PRODUCT: Six-Gun Select, Fast Draw, and Last Bounty Hunter

BULLETIN: SB-005

ISSUE: Distorted Sound from 4-Ohm Speakers

DATE: 5/12/2004

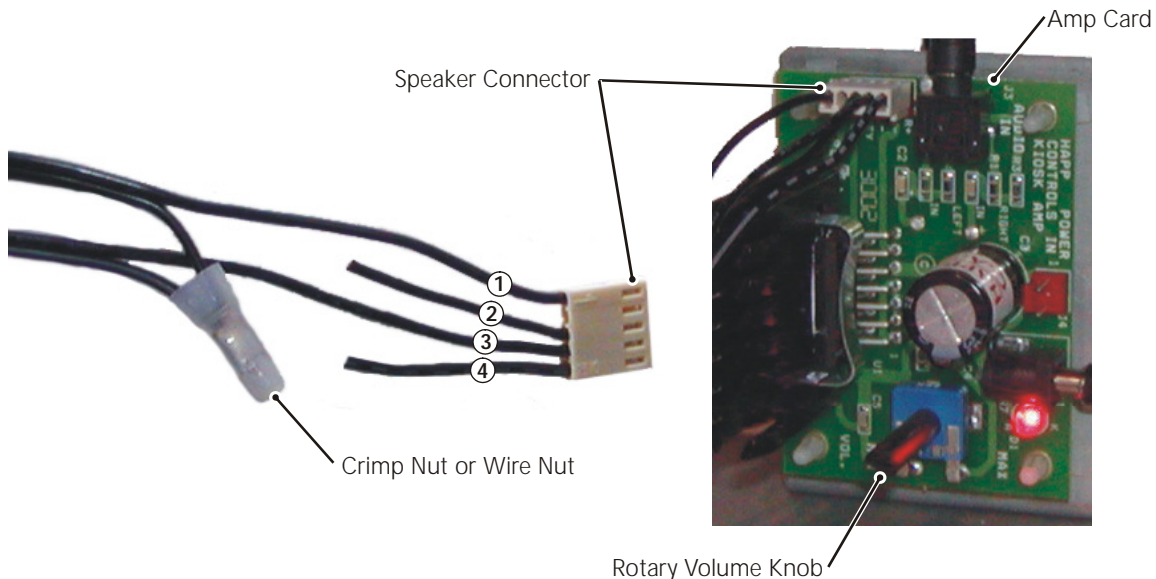
Some cabinets may experience distorted sound ("screeching") at higher volume levels. This problem affects models that have 4-Ohm speakers installed. Perform this procedure only as directed by GLOBAL VR Technical Support.

1. Turn the cabinet power OFF. Open the rear door of the cabinet to get access to the speakers. The speaker rating will be marked on the back of each speaker. Verify that you have "4-Ohm" speakers.
2. Open the coin door to gain access to the Amp card (marked "HAPP KIOSK AMP"). See the figure below.

3. Turn the rotary volume knob all the way down (counter-clockwise). Unplug the 4-conductor speaker connector from the Amp card. When unplugging, pull on the connector, not the wires.
4. Clip the #2 wire (-left) and the #4 wire (+right) about 1" from the plug. This will allow you to reverse the fix if necessary.
5. Strip about 1/4" of insulation from the non-plug end of the clipped wires. Use a suitable method (wire nut or crimp nut) to connect the wires together. Do not use electrical tape.
6. Plug the speaker connector back into the Amp card.
7. Turn the cabinet power back ON.
8. After the game launches, adjust the rotary volume knob until you are satisfied with the sound level. If you do not hear sound, check that you have clipped and joined the correct wires, and check that the connector is seated properly on the card.
